The Town of Erie

To: Heidi Majerik, Erie Land Company LLC
From: Hannah Hippely
Date: February 7, 2019
Re: SK-001023-2018 – Dearmin Sketch Plan No. 2 Application

To: Hannah Hippely
From: Matt Wiederspahn, P.E., Development Engineer
Date: December 12, 2018
Subject: **Dearmin East Sketch Plan**
CC: Russell Pennington
Wendi Palmer
Chad Schroeder

Subject: Dearmin Referral - Sketch Plan (dated October 19, 2018)

Figure 1a

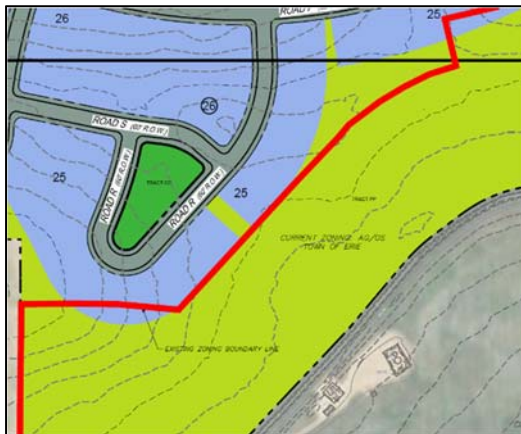
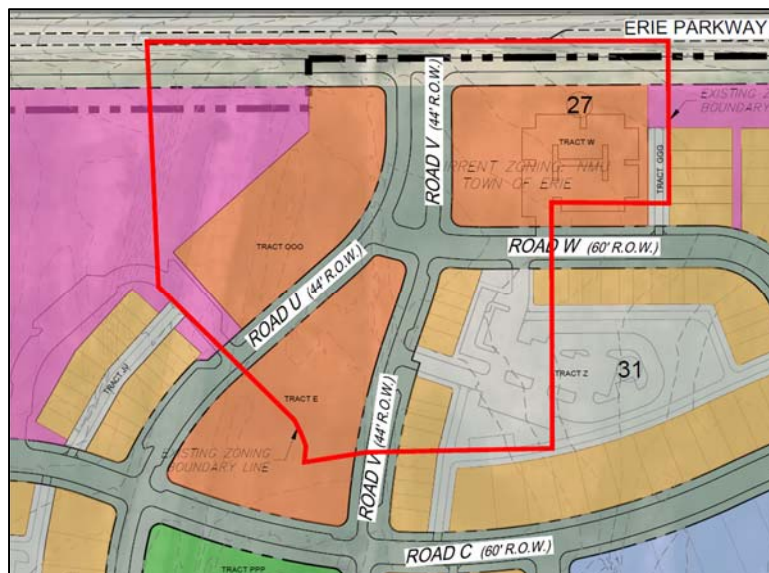
3. The property is currently zoned NMU, LR and AG-OS. The sketch plan proposed would require that the current boundaries be adjusted.
 - a. In Figure 1a and 1b below, the red line is the current boundary between the Low Density Residential (LR) District which is located above the line and Agricultural/Open Space (AG/OS) District located below of the line. In this sketch plan residential lots are proposed within the area zoned AG/OS and these areas would need to be rezoned to permit this.
